ADDENDUM NO. 001

Solano Community College District

Fairfield Campus Building Exteriors Project Phase 2

Date: July 12, 2021

⁶ TYPICAL ACCENT PAINTINGS AT ENTRIES
SCALE: NONE

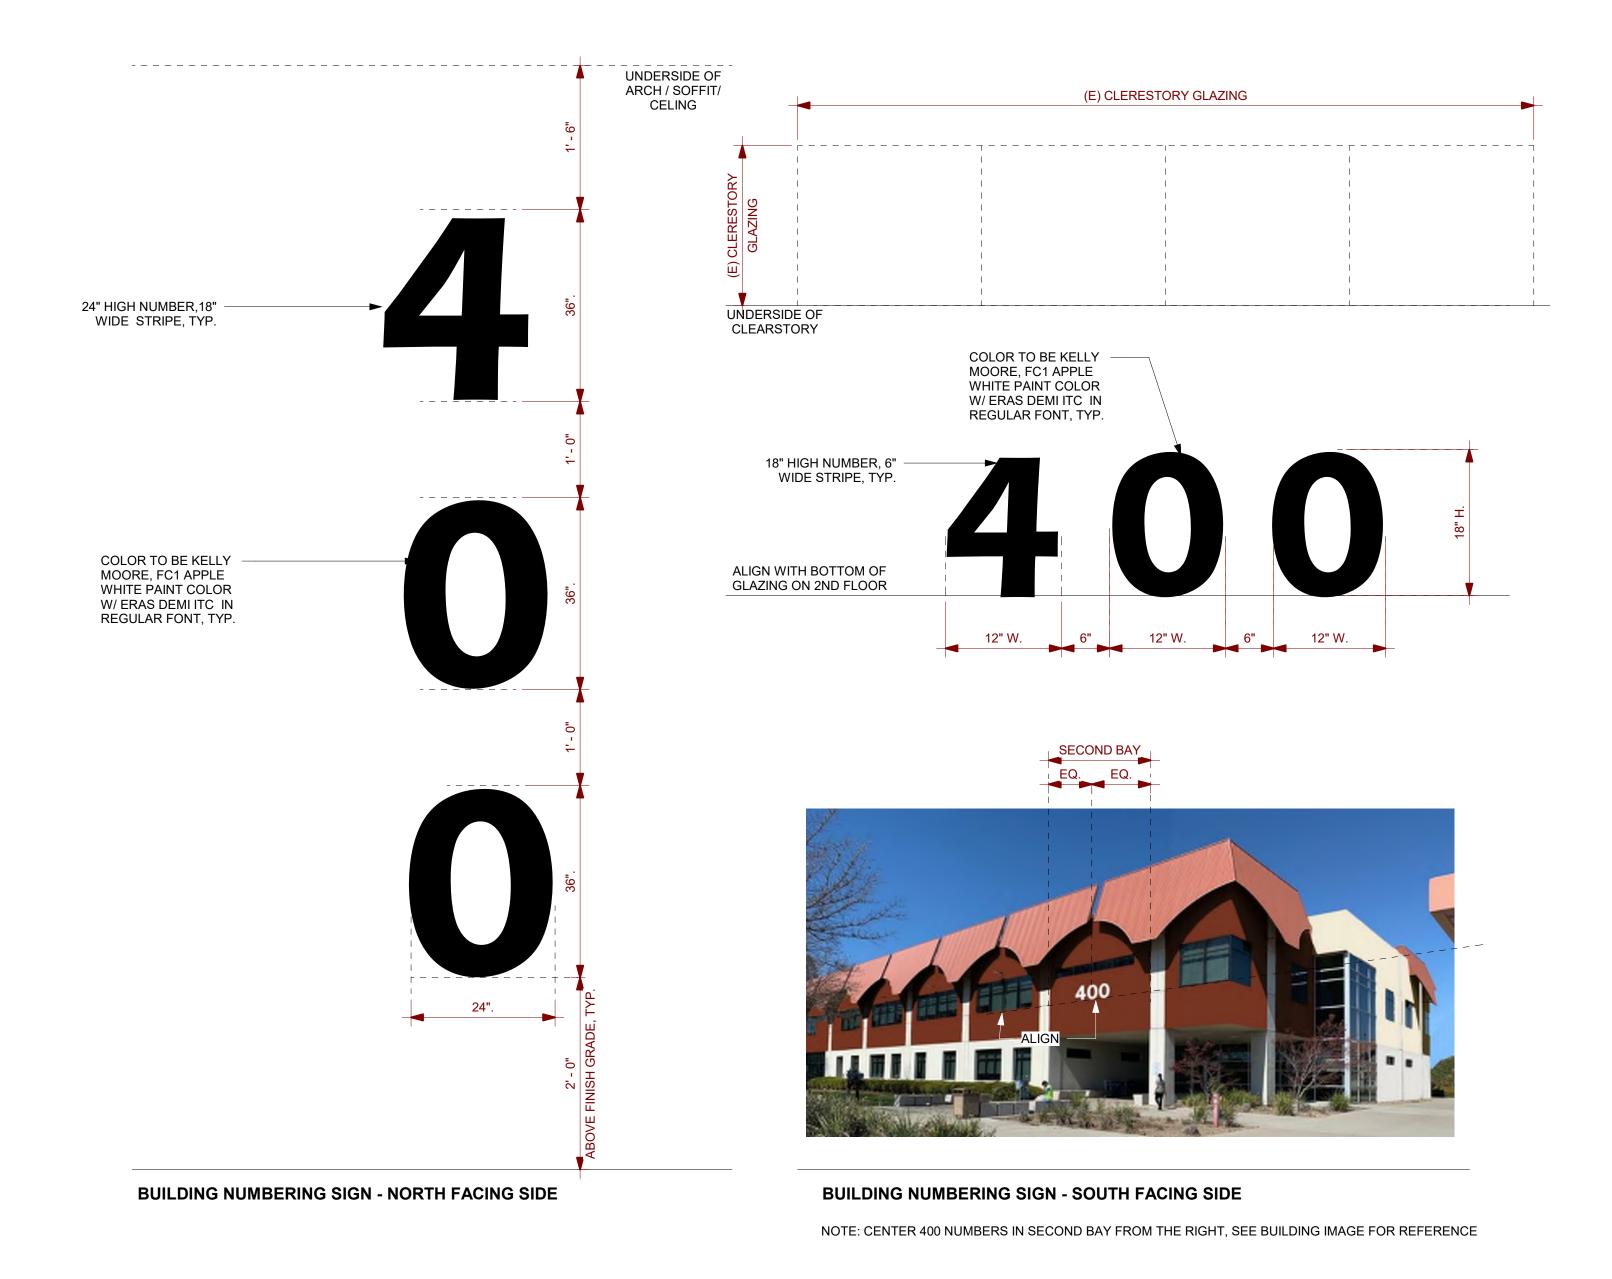
2.2. SHEET A6, DETAILS 1 & 4, BUILDING IDENTIFICATION SIGNAGE

Building Identification signage has been completed in phase 1. No new signage will be required for Phase 2.
